Addendum 02

PROJECT: Fort Loramie Local Schools Athletic Complex Building & Associated Improvements
600 East Park Street
Fort Loramie, Ohio 45845

PROJECT #: 25041.00

This addendum consists of 4 page addendum, 14 pages of exhibits, 4 specification sections and 39 drawing sheets

SHEET TITLE:
ENLARGED PLUMBING PLANS

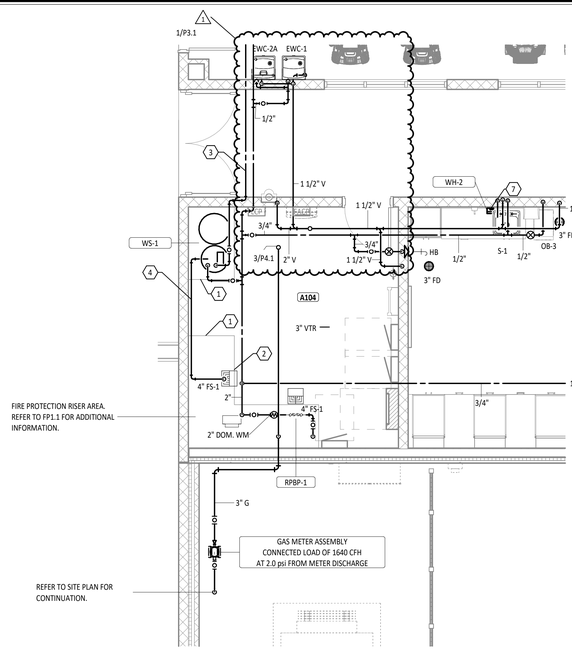
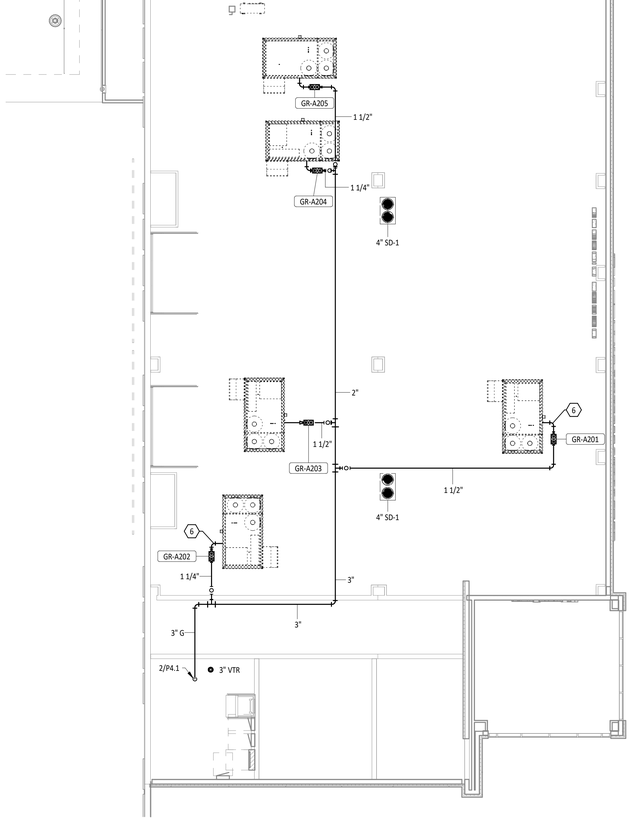
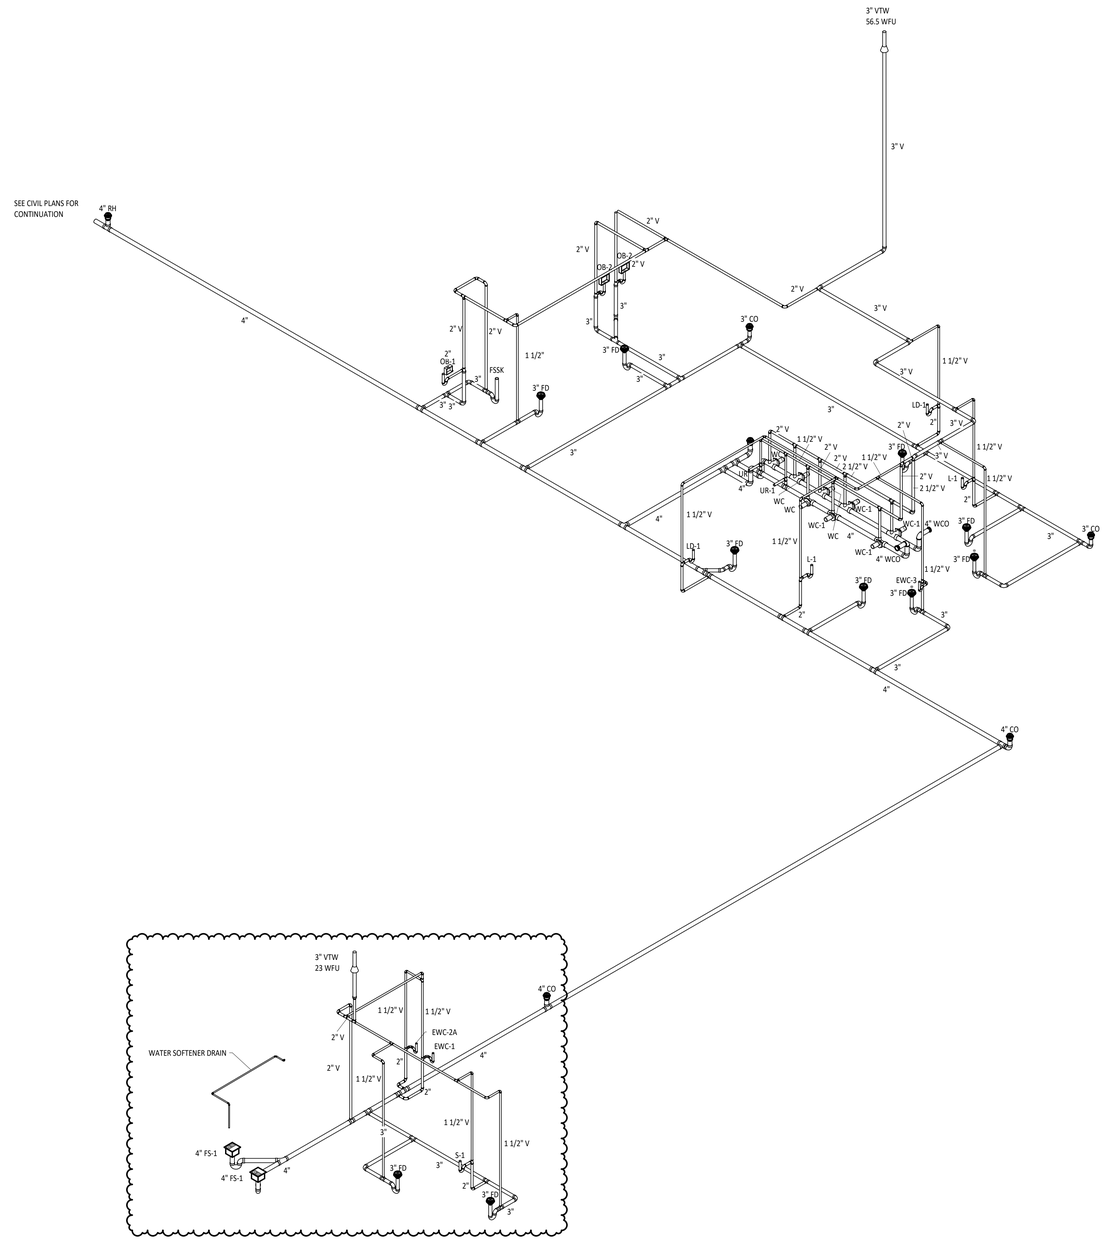
19.) P1.2 Site Plumbing Plan – New sheet showing site gas piping.
20.) P4.1 Enlarged Plumbing Plans – Move vent through roof to avoid ductwork. Reroute water cooler water and vent piping to minimize pipe in the corridor.

SANITARY ISOMETRIC

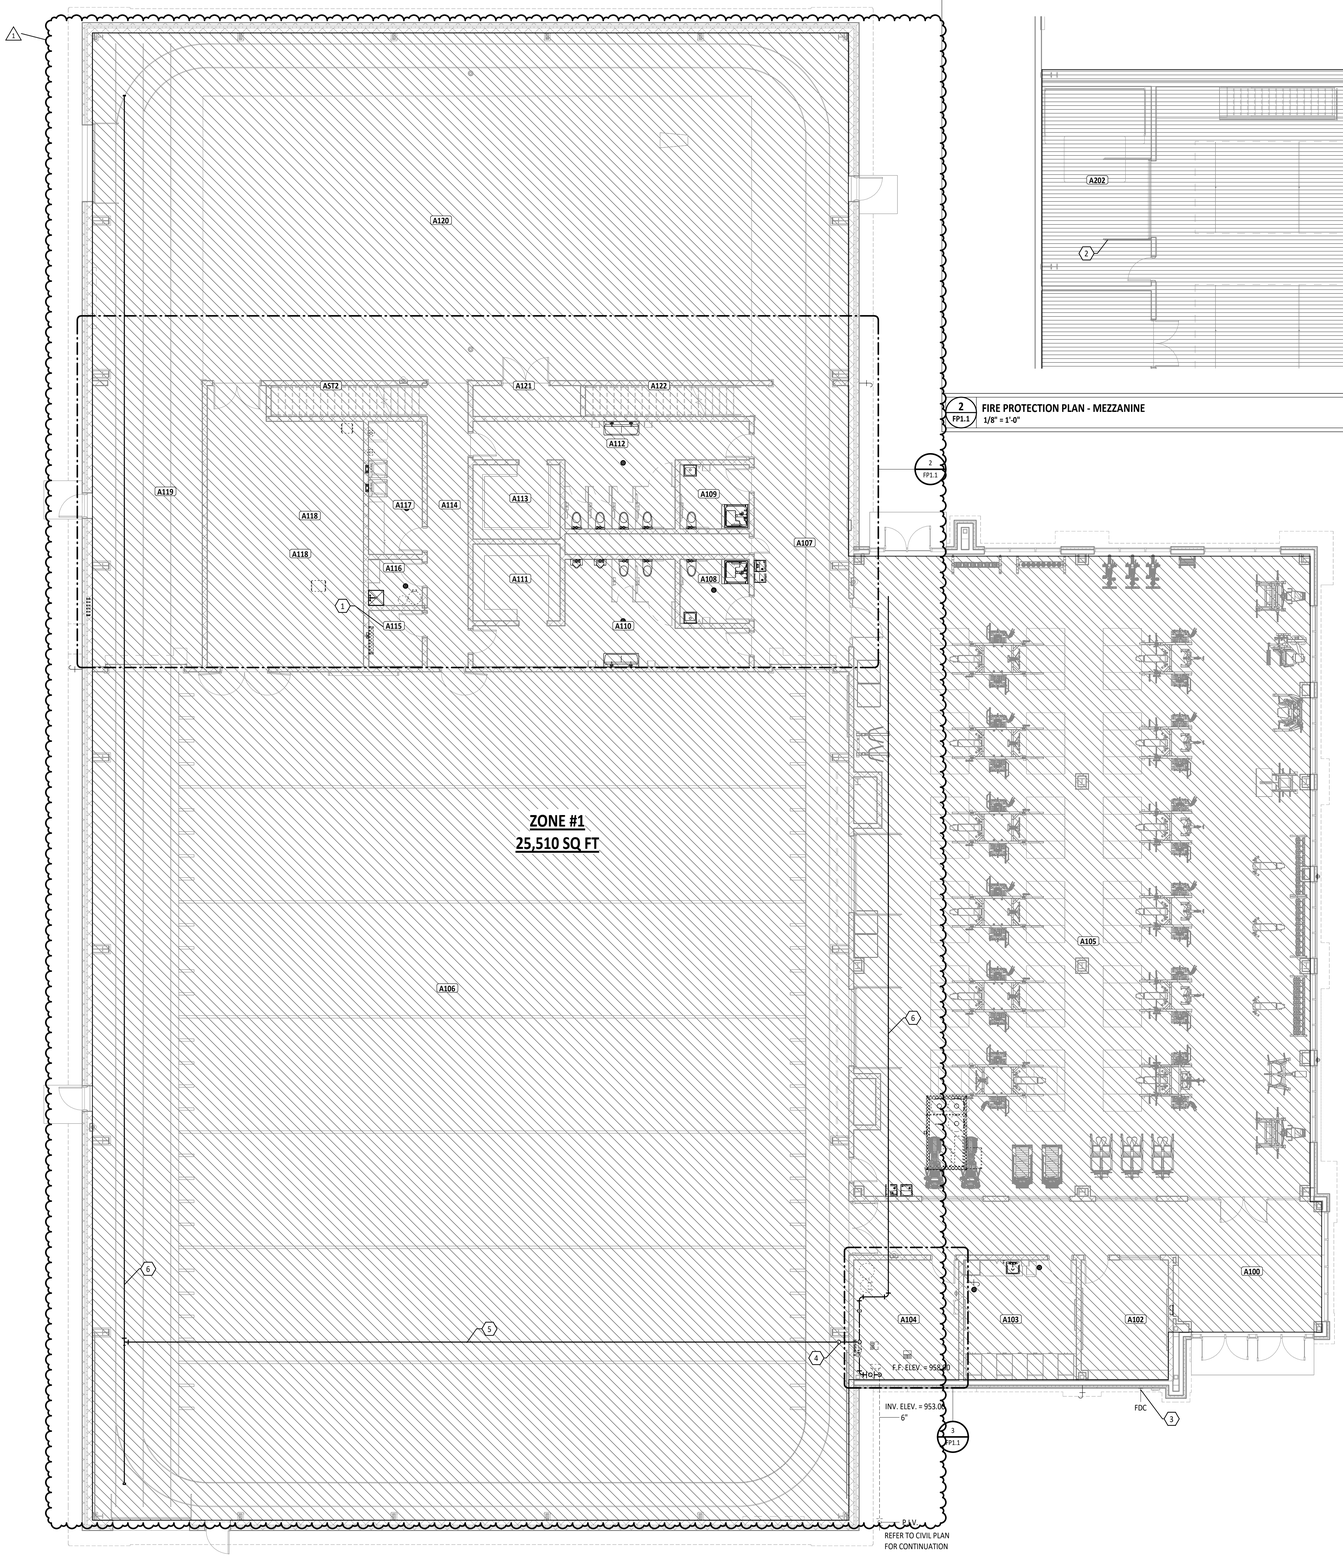
21.) P6.1 Sanitary Isometric – Move vent through roof and water cooler vent pipe.
22.) FP1.1 Fire Protection Plan –Add Sprinkler Mains and keynotes to clarify routing of the sprinkler piping.

1 E4.1 **FIRST FLOOR LIGHTING PLAN**
1/8" = 1'-0"

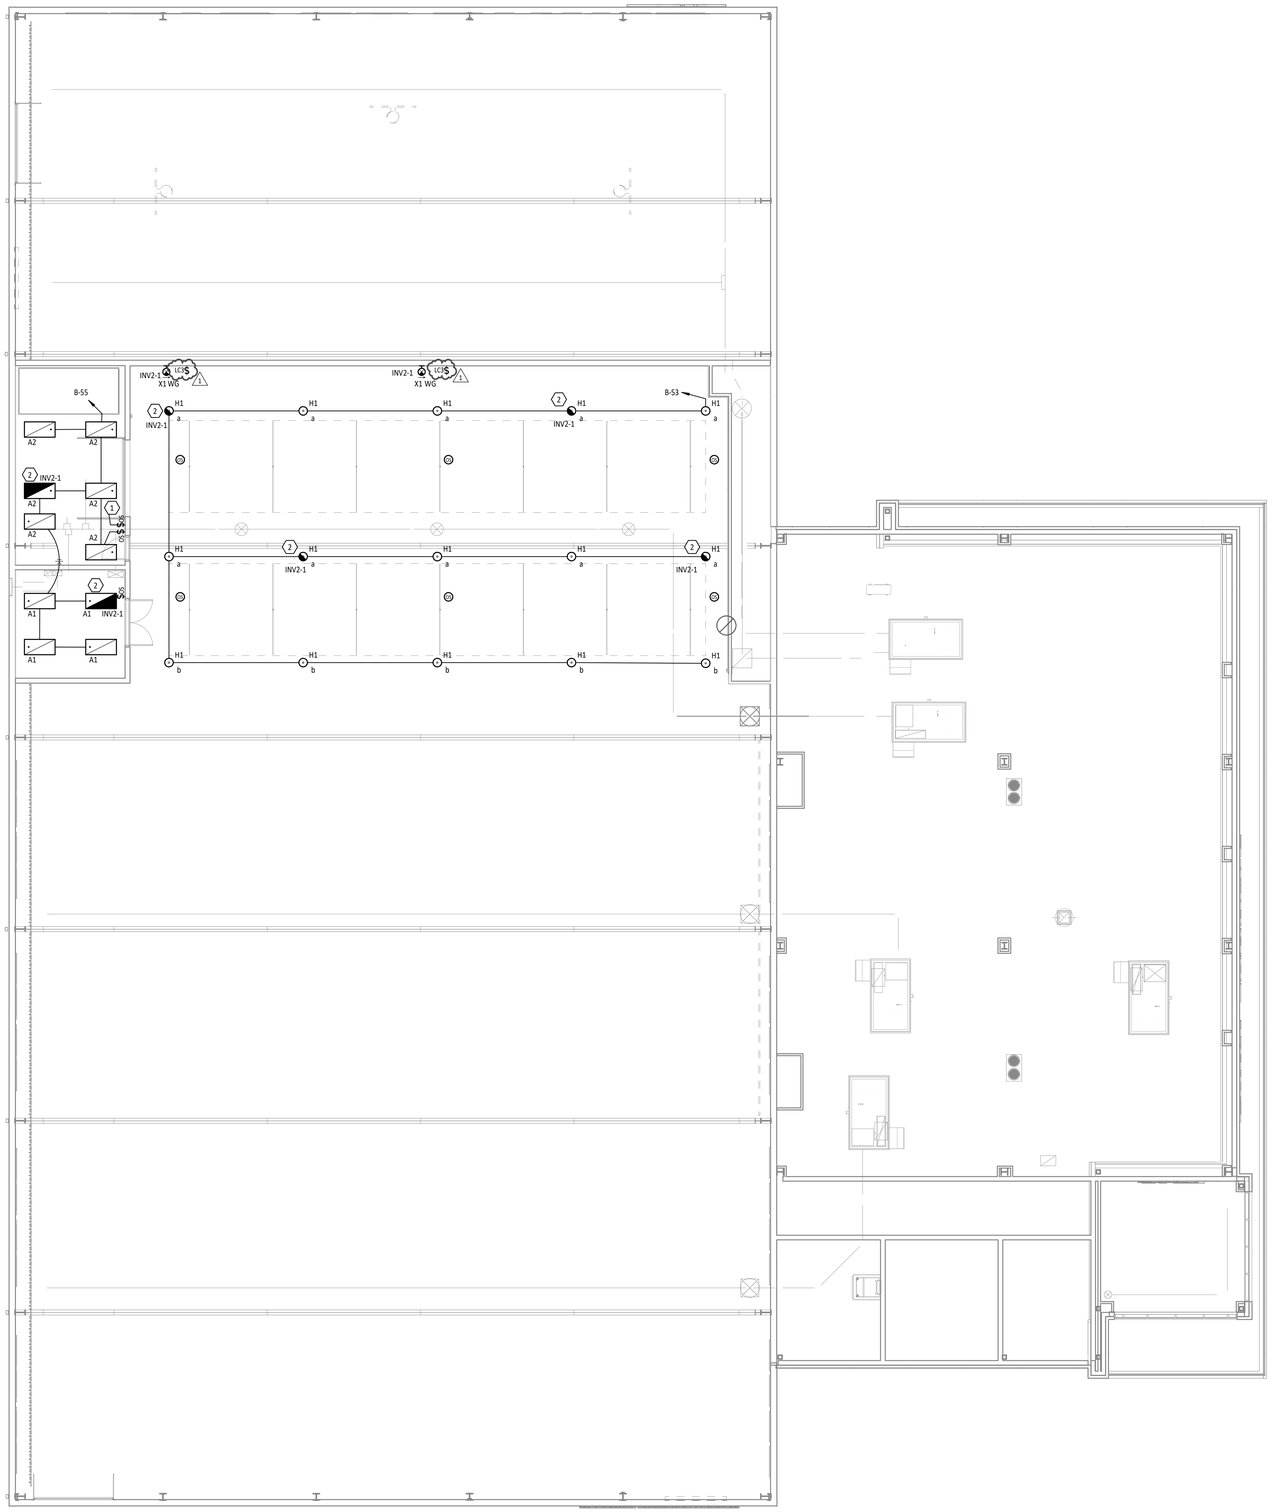
b. Update lighting control symbols to have manufacturer and product numbers called out.
24.) E4.1 First Floor Lighting Plan
    a. Revised light fixtures in A114

b. Revisions to the 'TA' lighting on the exterior of the weight room area.
    c. Added a key switch and circuit lines in A100.

d. Added a key switch in A101.
e. Added and updated lighting control switches in A105.
f. Added and updated lighting control switches in A106.
g. Added a key switch in A107.
h. Added a key switch in A110.
i. Added a key switch in A112.
j. Added a key switch in A114.
k. Added a key switch in A119.
l. Added and updated lighting control switches in A120.

SECOND FLOOR LIGHTING PLAN

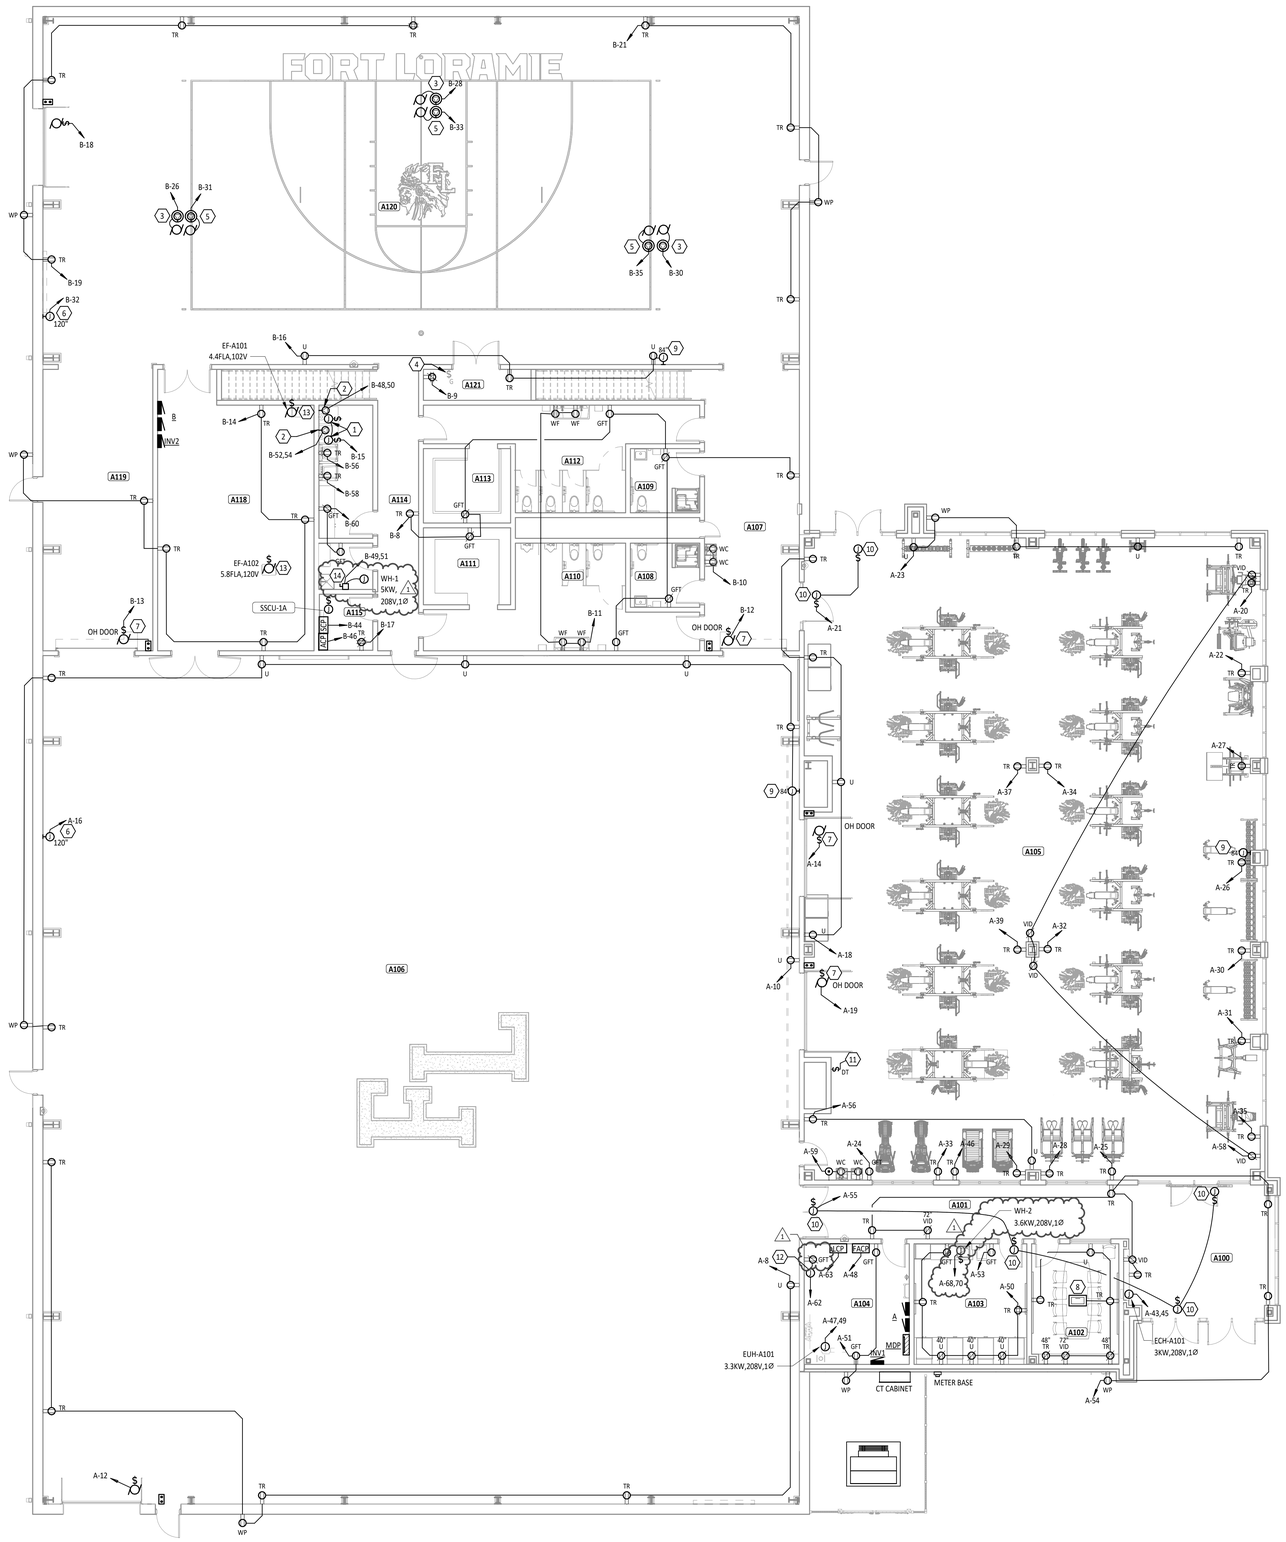
25.) E4.2 Second Floor Lighting Plan – Updated lighting control devices to be 3-way.
26.) E5.1 First Floor Power Plan – Add receptacle in A104 for water softener, add WH-2 connection in A103 and revision to WH-1 information in A116.
27.) E7.1 Luminaire Schedule – Add 'TA' fixture to schedule.
28.) E8.1 Electrical One-Line Diagram and Panel Schedules – Revisions to panel schedules.
